XCAL-Series

Release Note

Doc Rev: 09

Product Version: 3.3.4.124

Title	Show SIP option in Signaling Message window	Tech	
Product	XCAL-Series	Requestor	
Chipset	Common	CRM#	
Description of Enhancement/Fixes

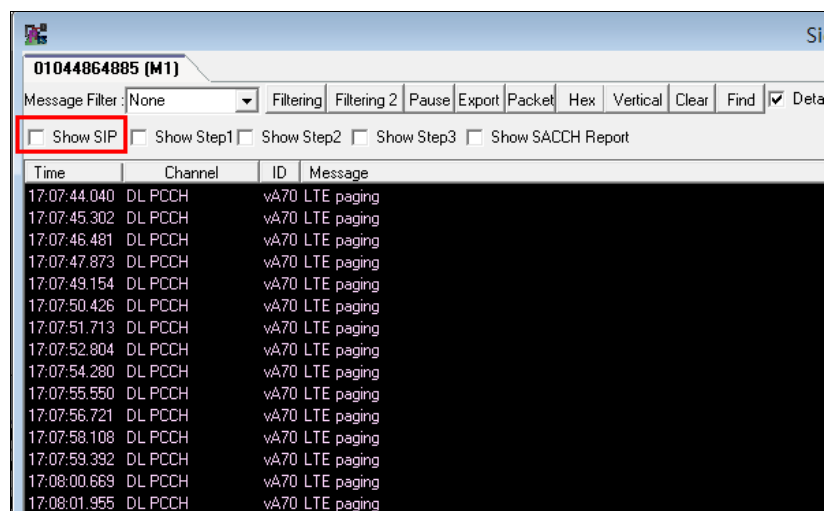
Added an option of **Show SIP** in **Signaling Message** window.

Show SIP option displays SIP status information in **Signaling Message** window.

Title	LTE(Adv)-Q Channel Quality Info	Tech	
Product	XCAL-Series	Requestor	
Chipset	LTE(Adv)-Q	CRM#	
Description of Enhancement/Fixes

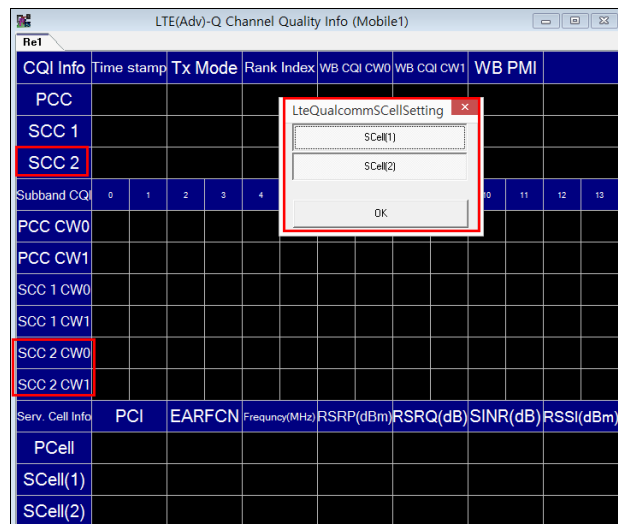
Added **SCC2** in **LTE(Adv)-Q Channel Quality Info** window.

Title	String Change in Alarm window for Virtual Memory	Tech	
Product	XCAL-Series	Requestor	
Chipset	Common	CRM#	
Description of Enhancement/Fixes

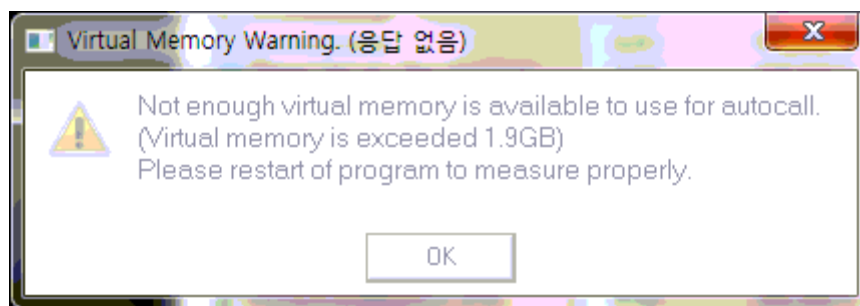
Enhanced the string in the alarm window for Virtual Memory.

Title	Android Scenario Edit window	Tech	
Product	XCAL-Series	Requestor	
Chipset	Android	CRM#	
Description of Enhancement/Fixes

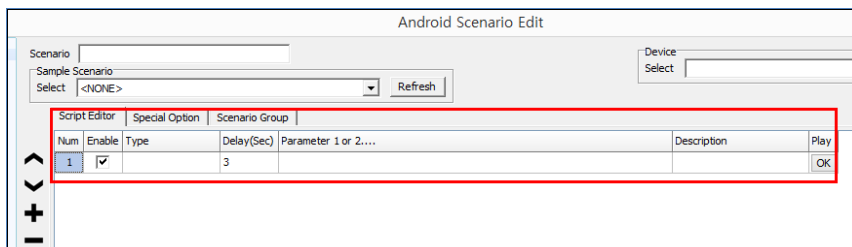
Enhanced to configure **Parameter** field in **Android Scenario Edit** window with 200 English characters.

Title	BTS Information File Open in PC with NO MS Office installed	Tech	
Product	XCAL-Series	Requestor	
Chipset	Common	CRM#	
Description of Enhancement/Fixes

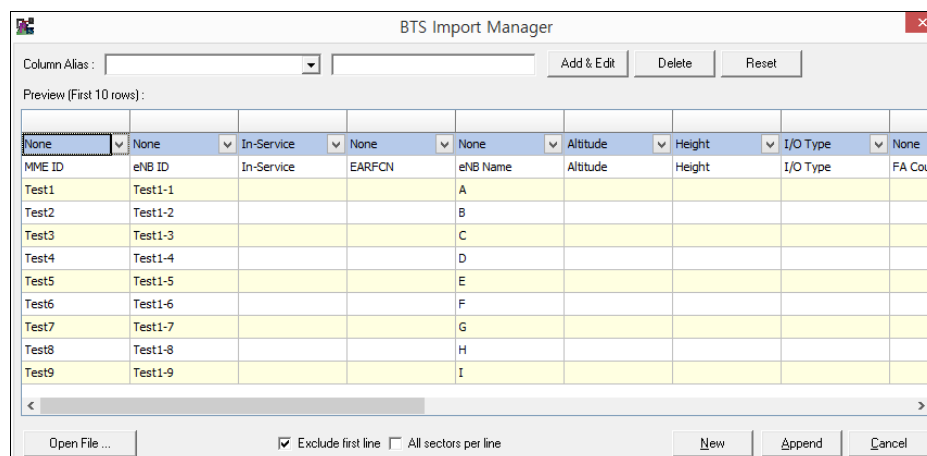
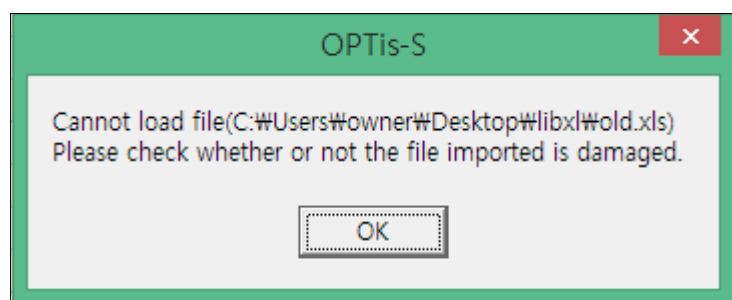
Fixed to open BTS information file in PC with no MS Office installed.

When importing a corrupted file, the following alarm window appears.

Title	Power off option	CRM#	
Description of Enhancement/Fixes

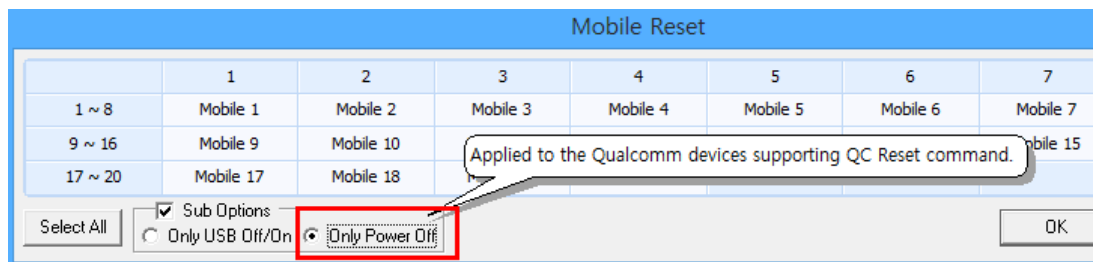
Added Option to Power off to Mobile Reset window of M(II), MTS.

Title	Delete original file feature	CRM#
-------	------------------------------	------

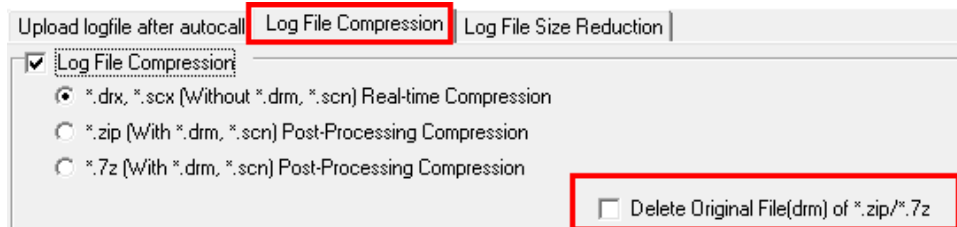
Added feature to delete original file when compressing Log file.

Title	Delay on the Network Entry start Point	CRM#	
Description of Enhancement/Fixes

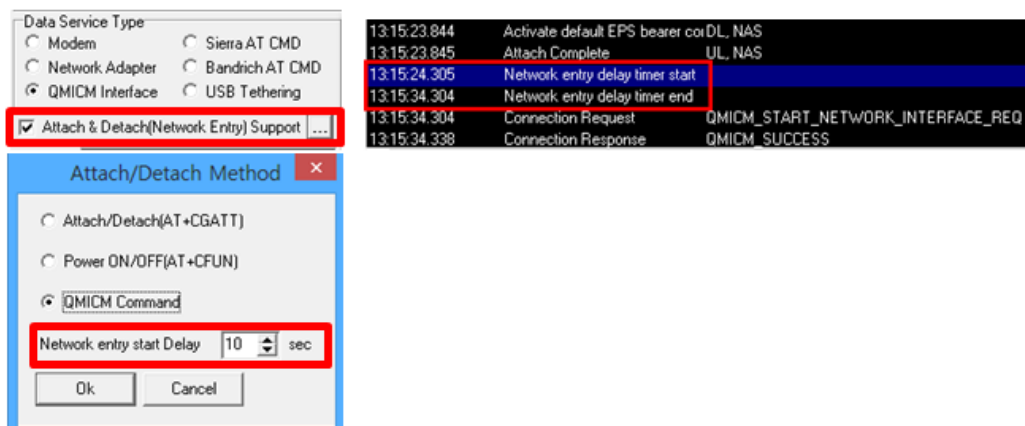
Added option to configure Delay on the Network Entry start Point when using Attach & Detach(Network Entry) Support option of QMICM Interface.

Title	Smart App BluetoothLE Status	CRM#	
Description of Enhancement/Fixes

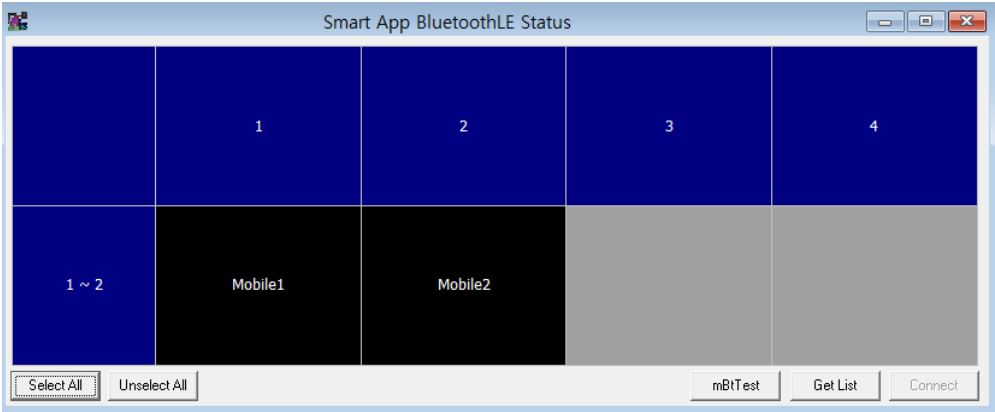
Implemented Smart App BluetoothLE Status window.

Title	Alias	CRM#
Description of Enhancement/Fixes

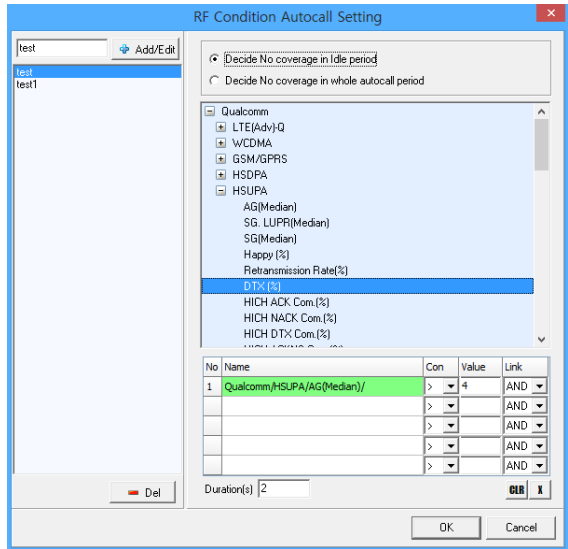
Added Alias to RF Condition Autocall Setting.

Title	ESP As Edit	CRM#	
Description of Enhancement/Fixes

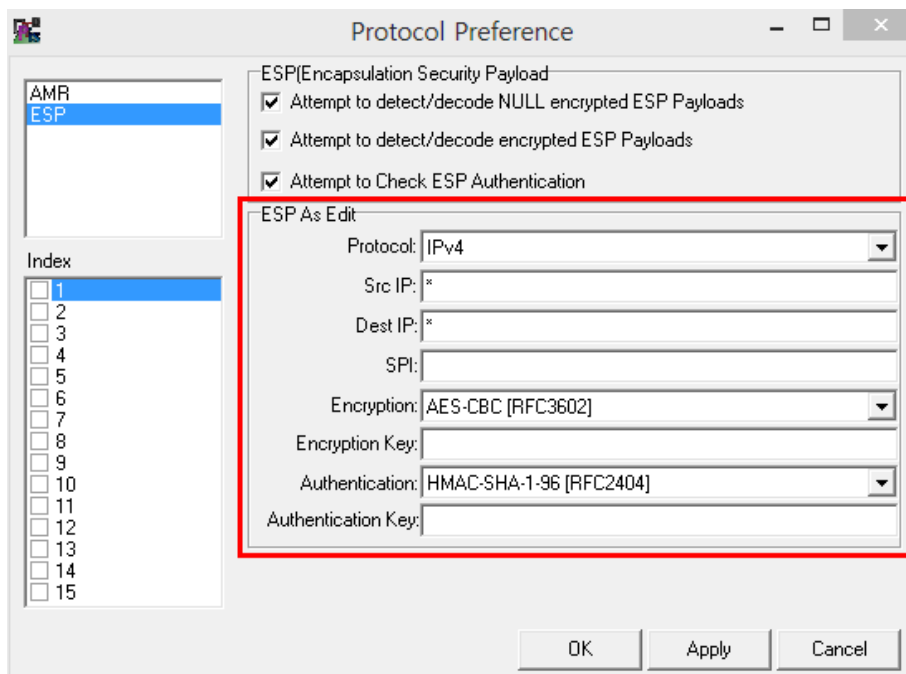
Added ESP As Edit to Protocol Preference window.
